Front entrance (this whole entrance is in a vestibule. Patrons Have the option of going left or right through another set of doors To get to the library):

# Quotation

University of Maine at Fort Kent Library  
 23 University Dr.  
 Fort Kent, Main 04743

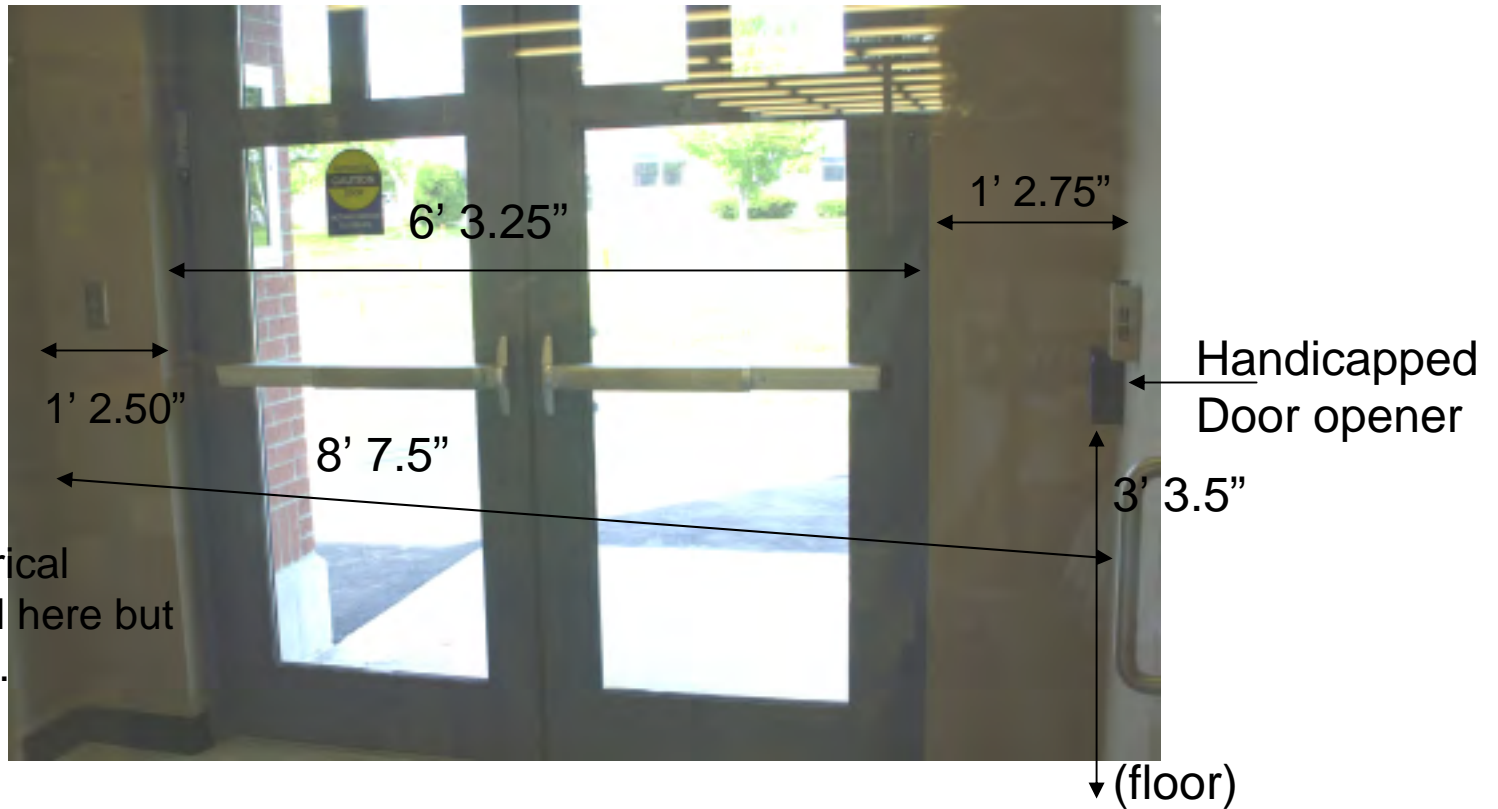
Using the two directional (PCW-SBA02) sensor, please describe how you would install it here (where and exactly how?). Are there multiple options?

Back entrance (always an open double door):

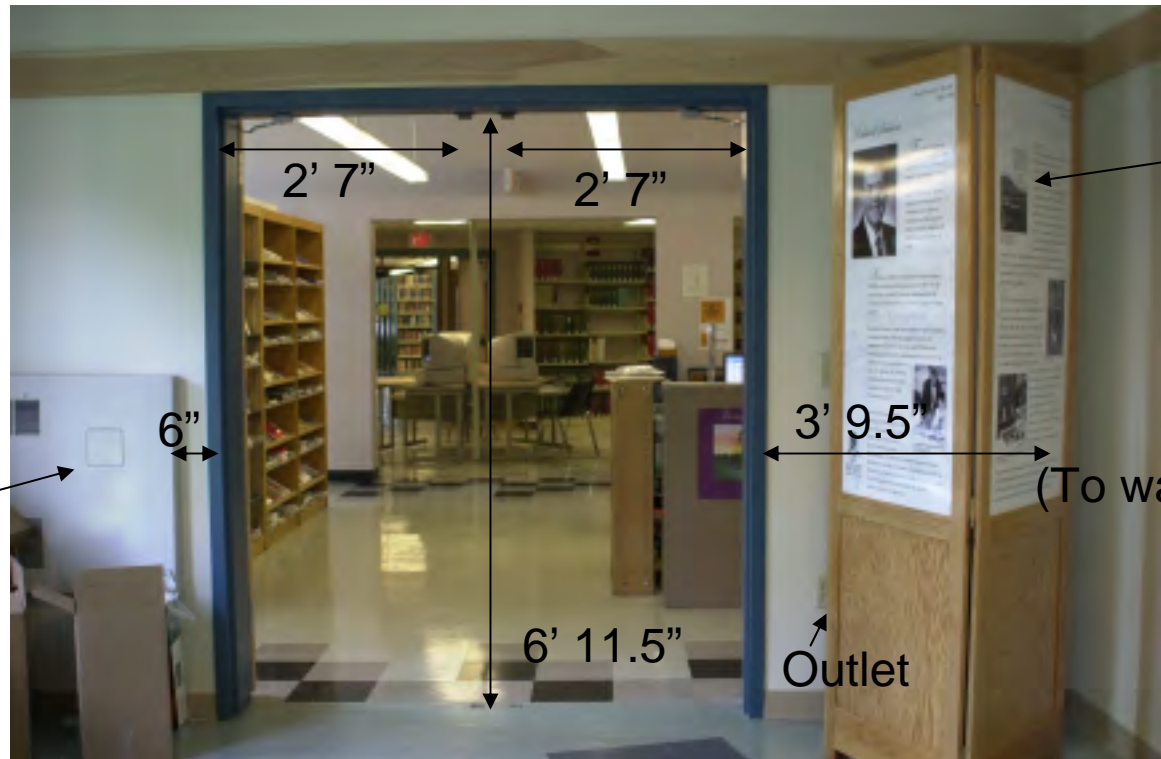
Pretend this Isn't here.

This is a heater.  
It is 2.5" wide.

What are our options here for installation. Please describe where and how the two directional (PCW-SBA02) sensor (s) would be installed? In other words what ways would a horizontal (no reflector) be mounted if it can, and how would you mount the verticals (what angles, etc.)?
